**DESCRIPTION: Malcolm C. Hursey Montessori School at Ron McNair Campus
 Building No. 0734**

This addendum consists of the following attachments:

1.3 DRAWINGS

BID SET
SITE DETAILS

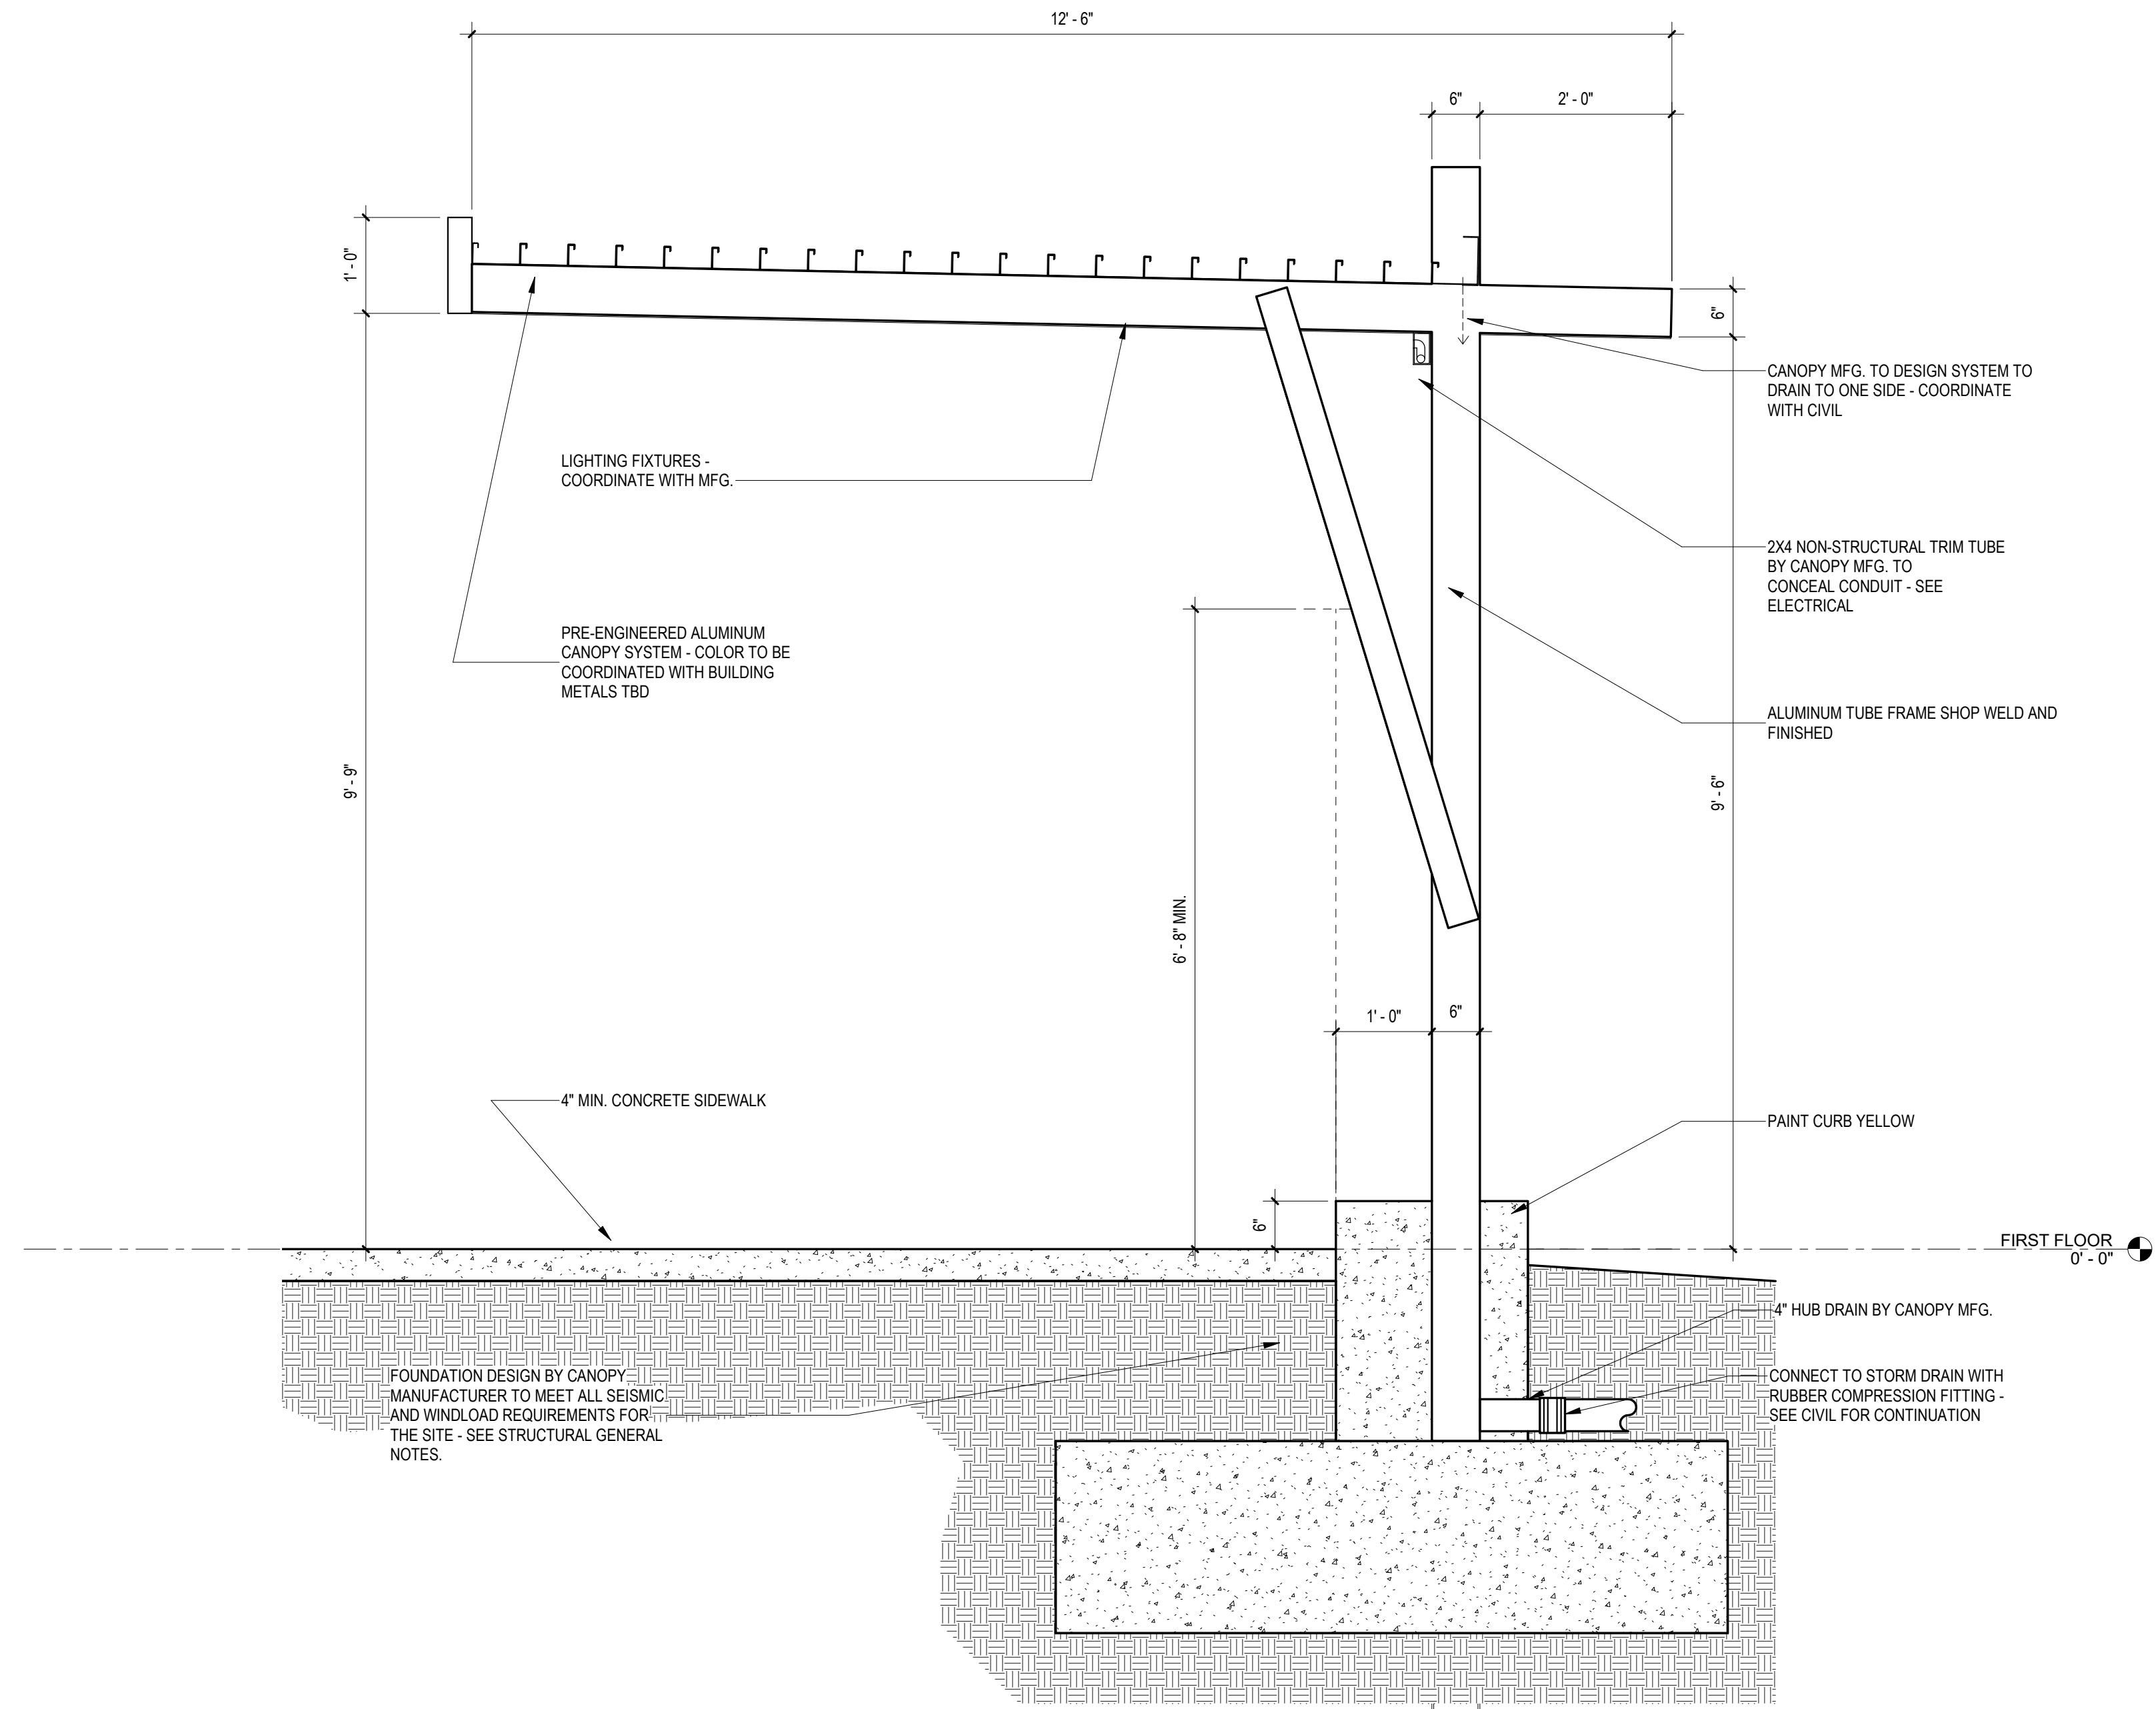
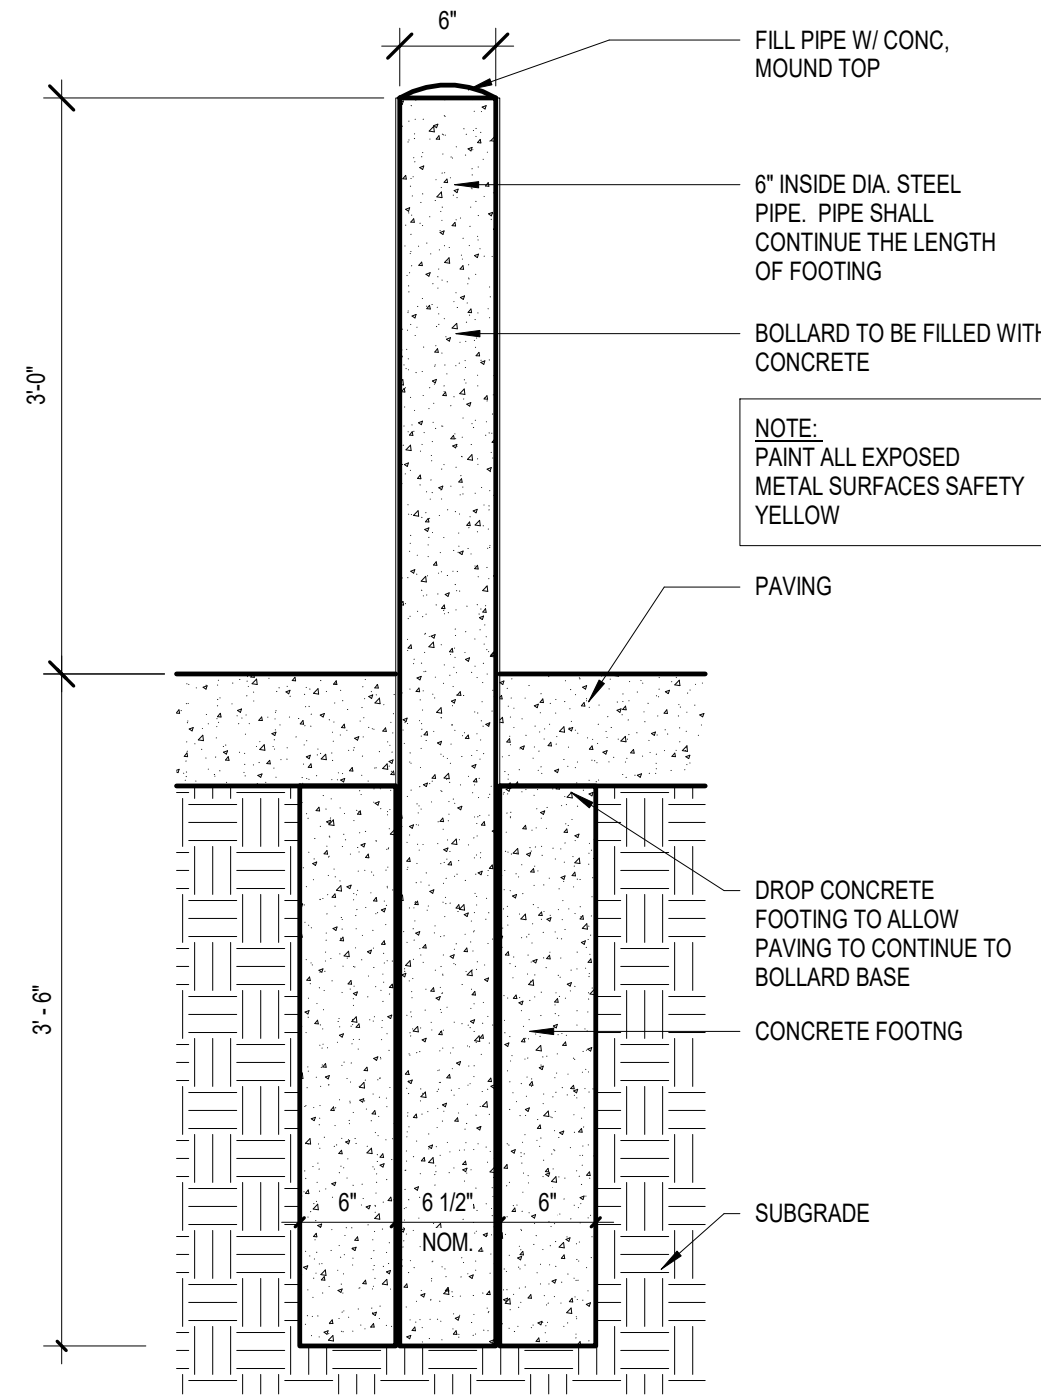
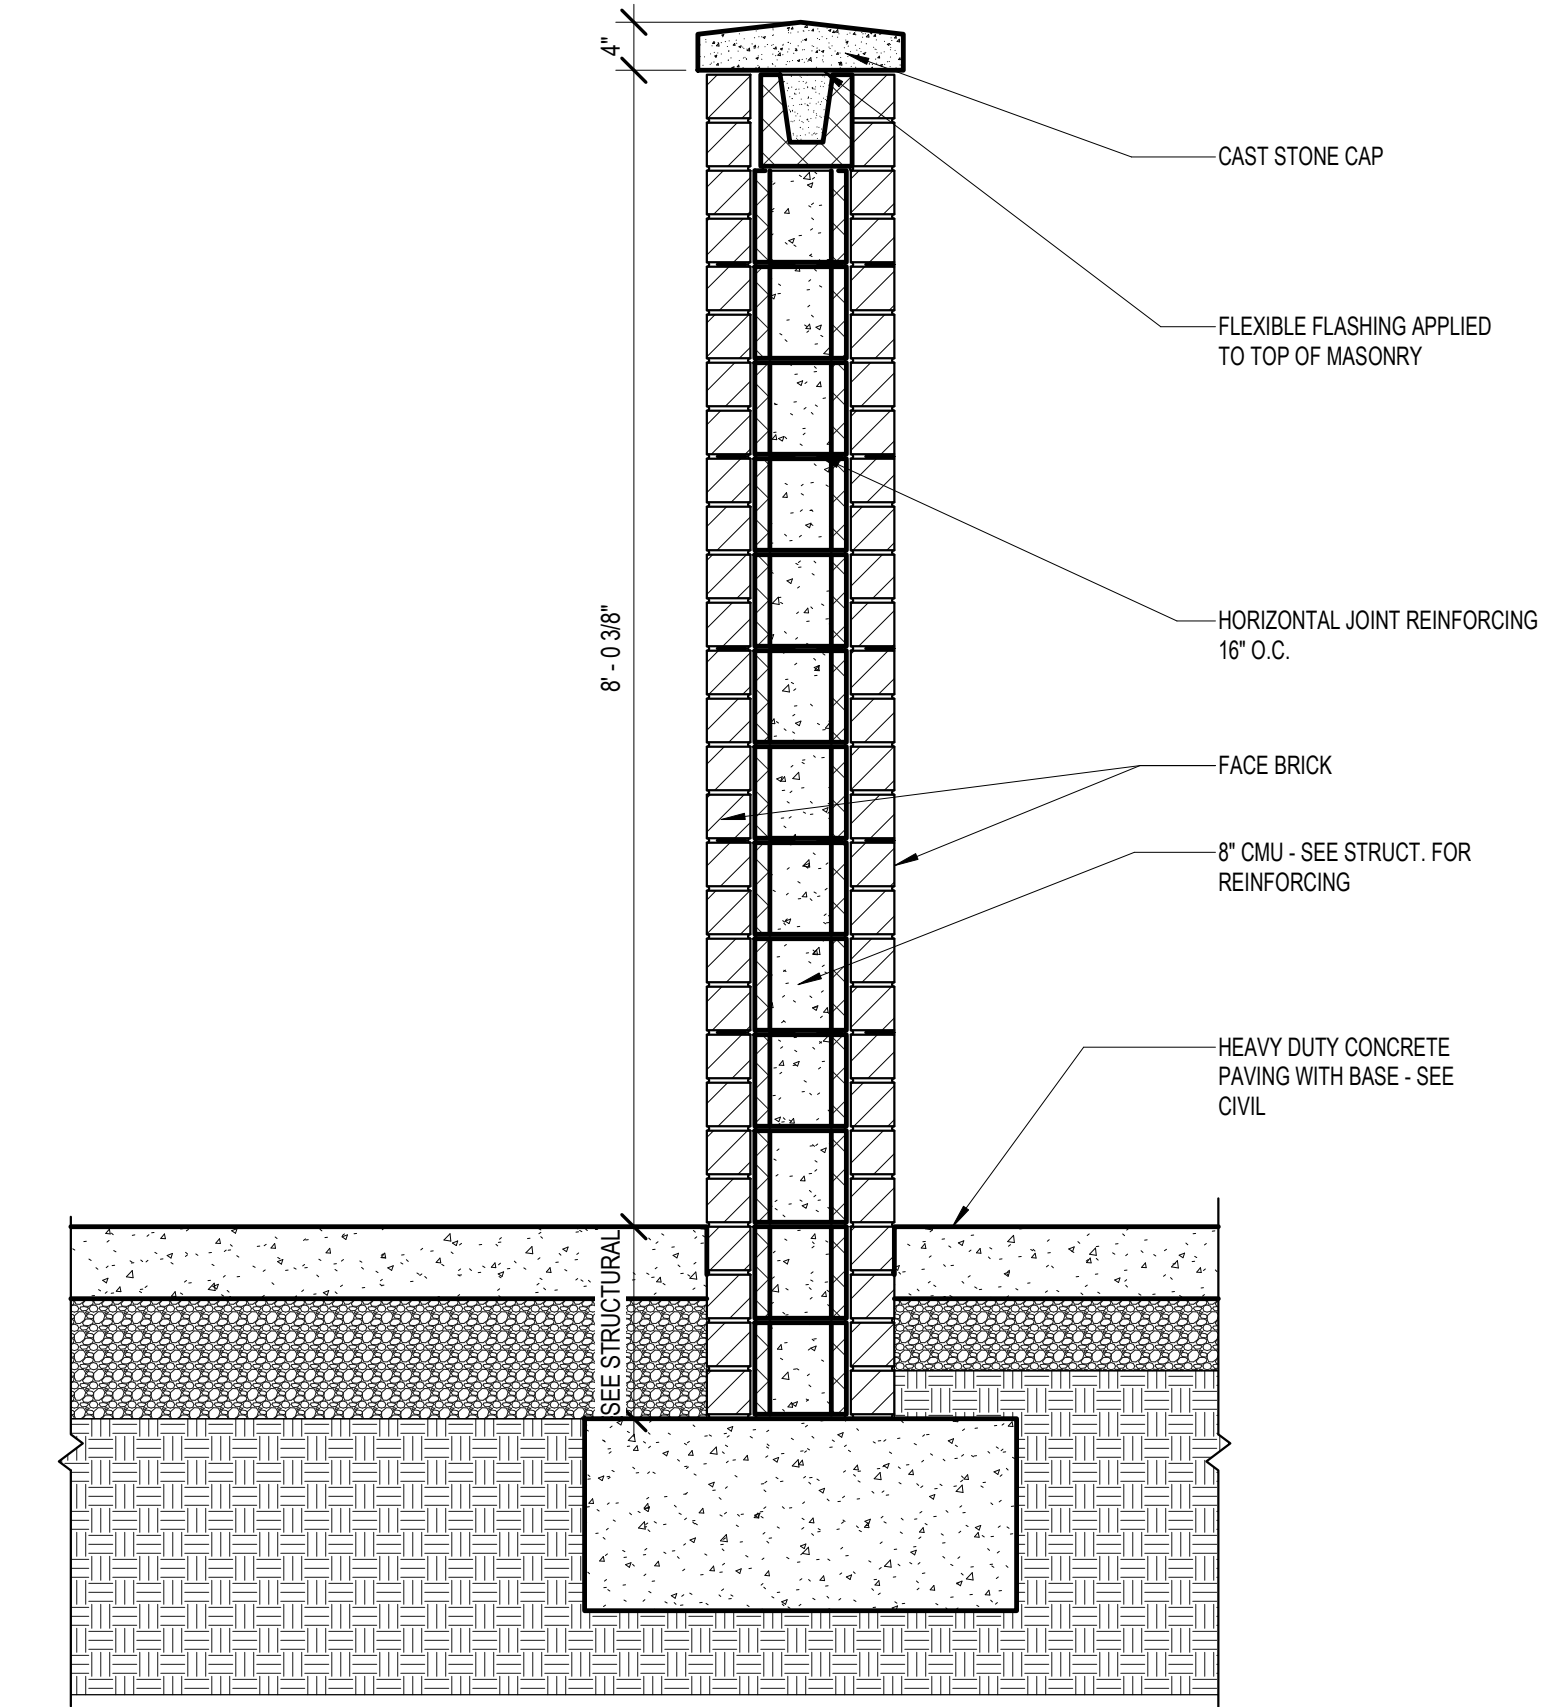
1. A0.03 SITE DETAILS
Updated wood privacy fencing detail
2. A0.04 SITE DETAILS
Added Sheet A0.04
3. A1.00 ARCHITECTURAL SITE PLAN
Revised wood privacy fencing, added detail references to the dumpster enclosure and garden shed.
